NON-REAL TIME HYDRAULIC MODEL REVIEW

Project	Bognor Regis Golf Club	Job Number	70088068	Required coastal standard (if applicable)	
---------	------------------------	------------	----------	---	--

Model Type	1D/2D	Software	Other	2nd review	3rd review	4th review
Revision	1	Date	08/07/2022	08/09/2022		
Area Client	EA	Reviewer	B Watson	P Sale

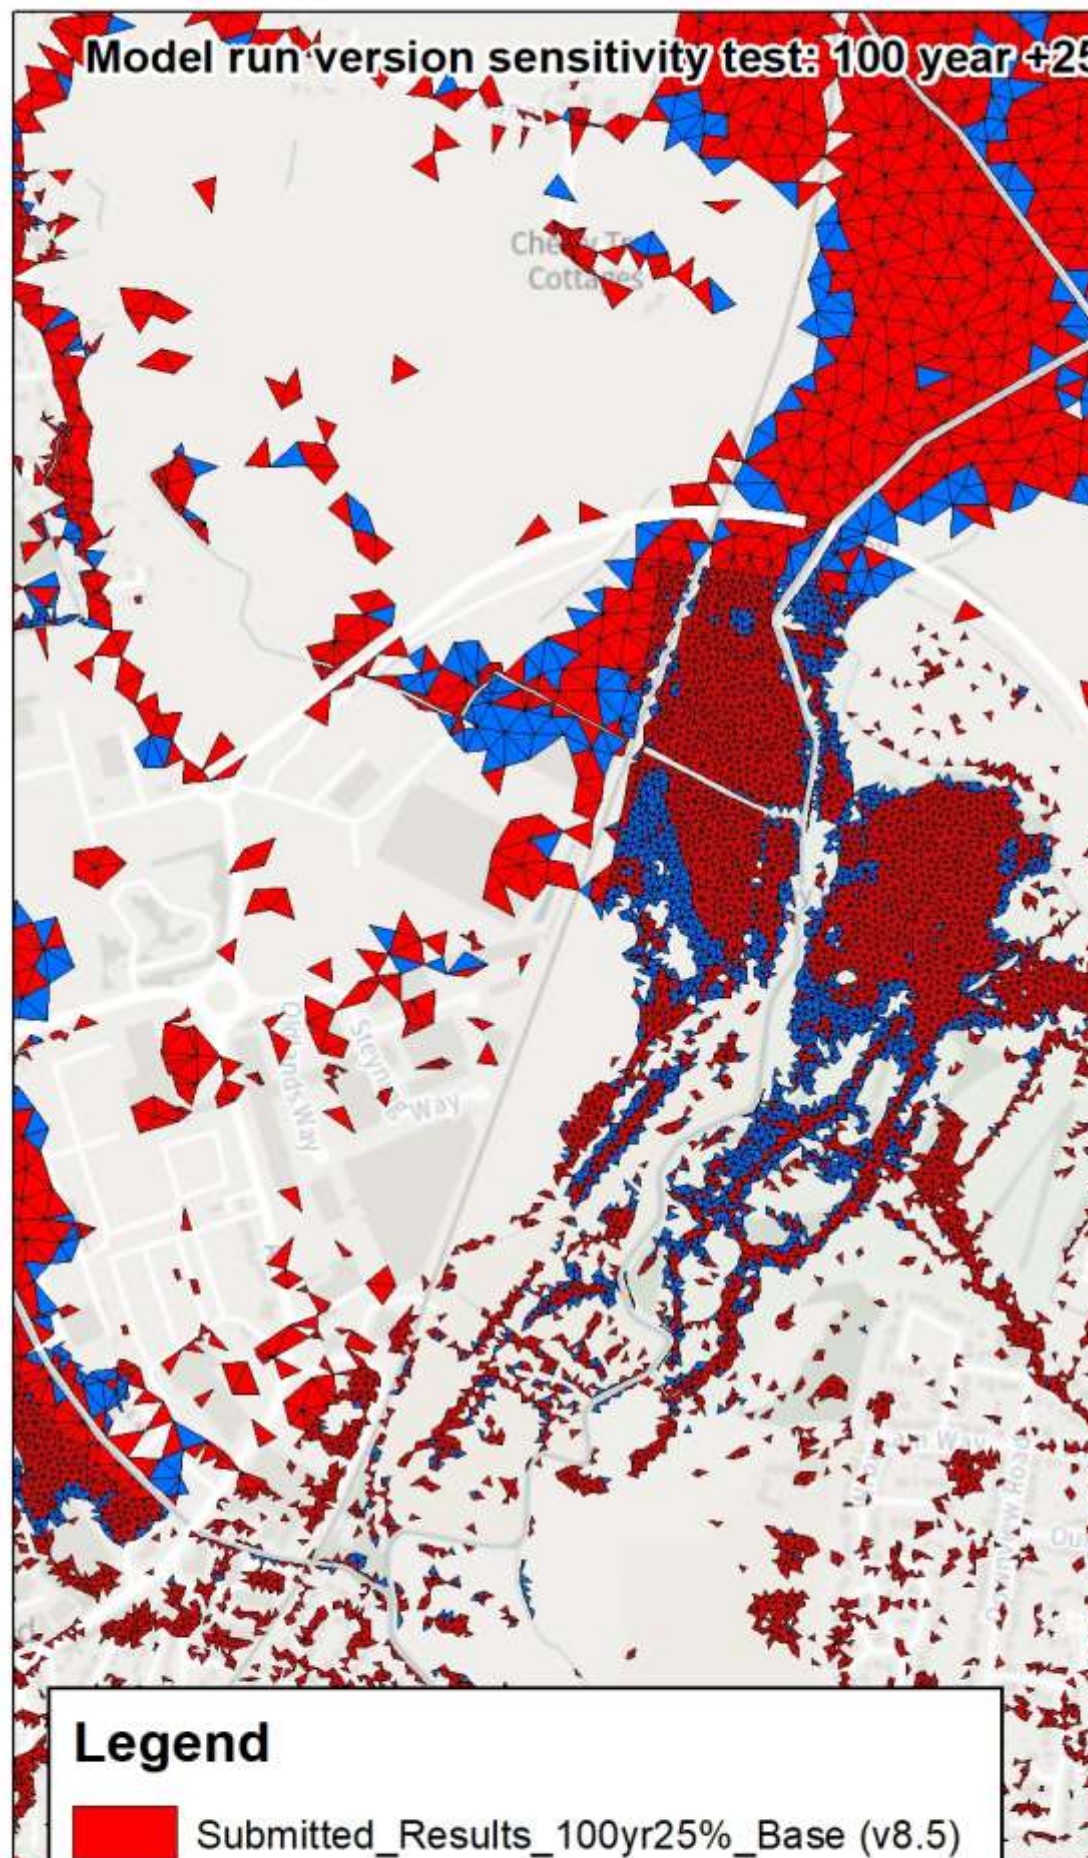
15.4	Are simulated floodplain extents similar to recorded extents? Are flow routes similar?		No details of verification provided	Provide justification for verification not being carried out	See photo below of historic flooding. Blue circle matches with the modelled flood risk in the north of the site where there is no development. Residential then located in the red circle which is shown to be drier

15.5	Has suitable effort been made to attempt and improve calibration. Have attempted changes been documented with a quantification of impact?		No details of calibration provided	Provide justification for calibration not being carried out	This modelling was based on an existing EA model and just the area of interest updated. It was assumed that where calibration was possible that had been undertaken as part of the original modelling. No additional data was provided to allow any calibration. Photo of historic flooding has however been compared to model results - see below

2nd Review Comments	2nd Review Response (DATE)	3rd Review Comments	3rd Review Response (DATE)
The previous modelling calibration was undertaken using three recorded events, June 2012, November 2010 and December 2012. An extract from the JBA (2015) report is included within the comment for this cell. It appears as though model calibration was reasonable in the previous JBA (2015) modelling. Given that the previous model has been calibrated, additional updates are fairly minor, and comparisons with historical anecdotal evidence, no further action is deemed necessary			
Inspection of historic flood outlines held by the Environment Agency (I\$\\National\\Physical\\Hydrology\\flood_event_outlines.shp) show no historic flood outlines at the development site (although this is not a record of all flooding, only what the EA holds). There are some similarities when comparing the 100 year +25% (applying a depth cutoff threshold of 0.02m) with the existing Flood Zone 3 extent although the 100 year +25% extent is generally smaller.

Map comparing model results for the baseline 100 year scenario (100 year 10.25 hr mm/hr +25%CC) based on runs undertaken with Infoworks ICM version 8.5 and version 2021.9. A depth cutoff of 0.05m has been applied to both sets of results ("DEPTH2D">0.05)

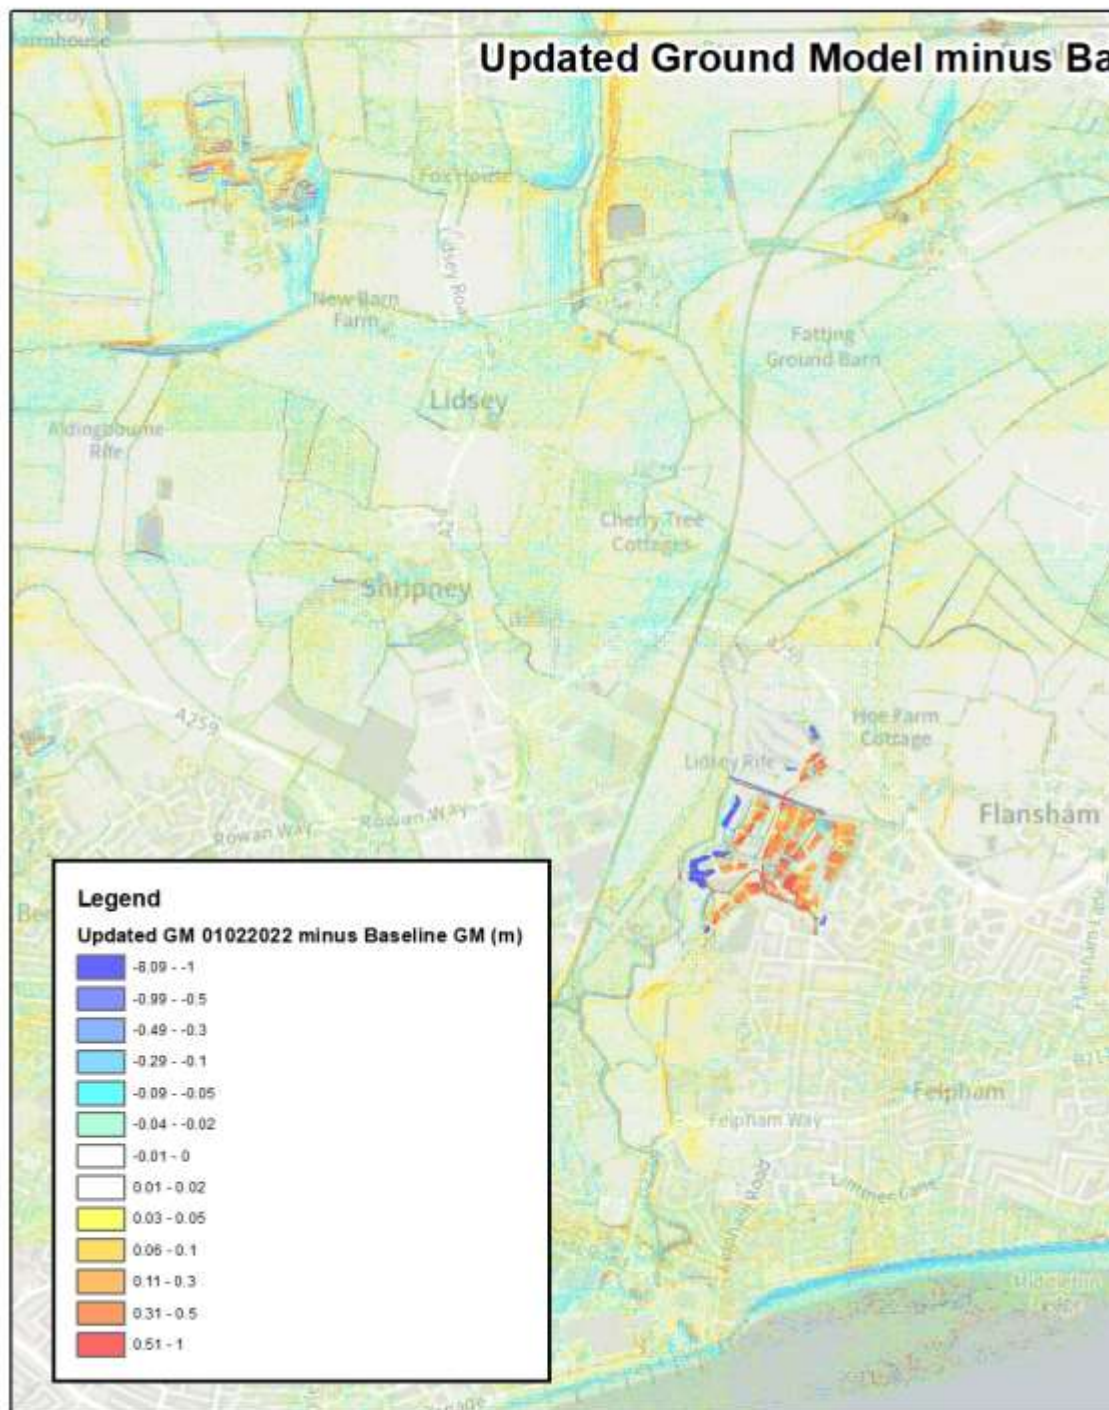
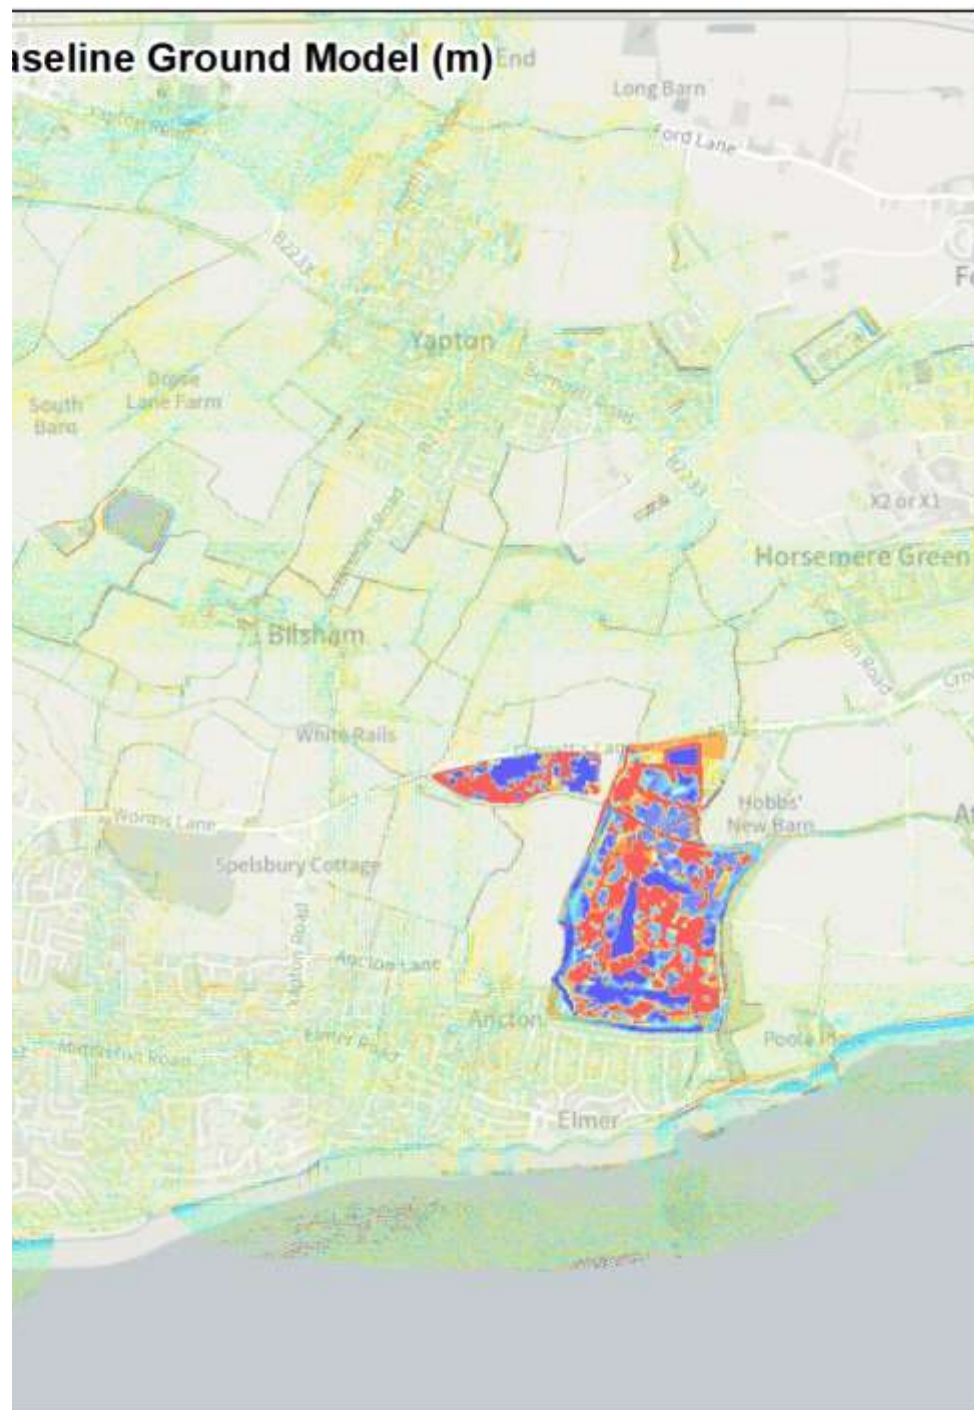
2nd Review Response (DATE)	3rd Review Comments	3rd Review Response (DATE)	4th Review Comments	4th Review Response (DATE)
The 27.5hr storm duration results are now provided and show no impact.

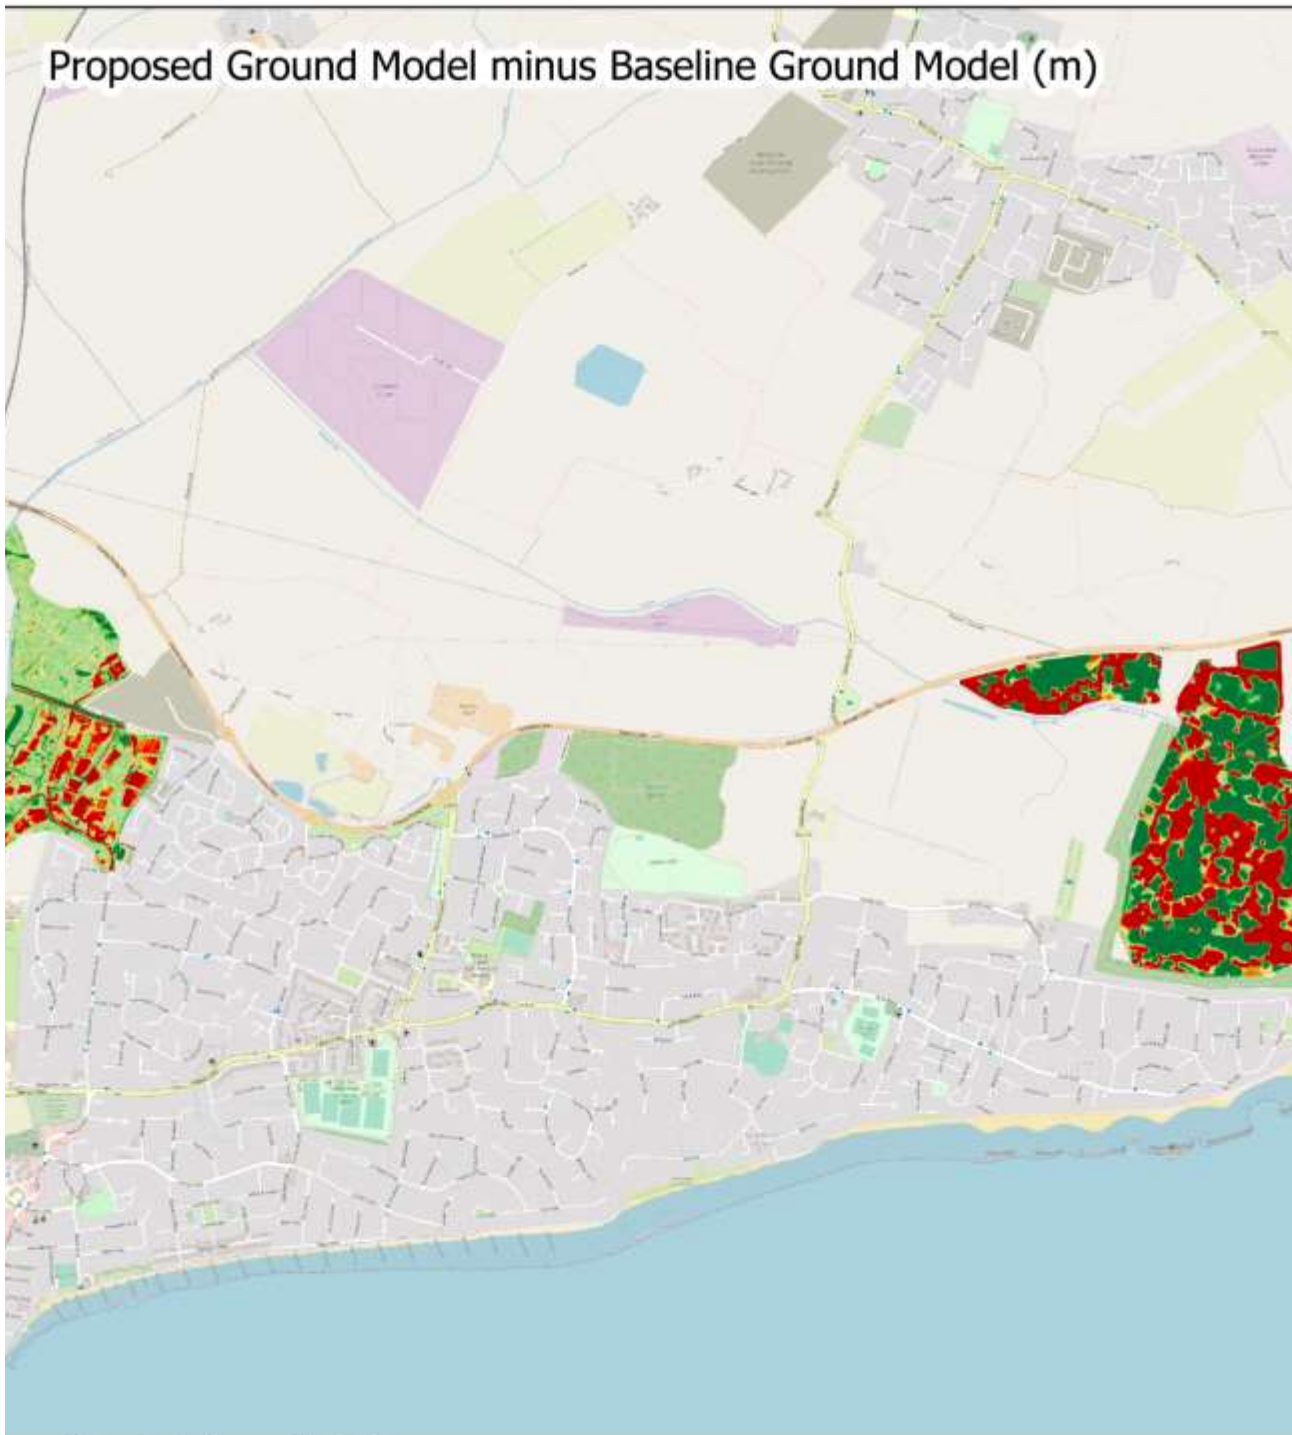
On the left is a comparison between ground
baseline GM.asc and Updated GM
asc . It appears as though there are
discrepancies in elevation outside of the areas where re-
development is proposed. It would be expected that
the models would be consistent outside of the
development areas
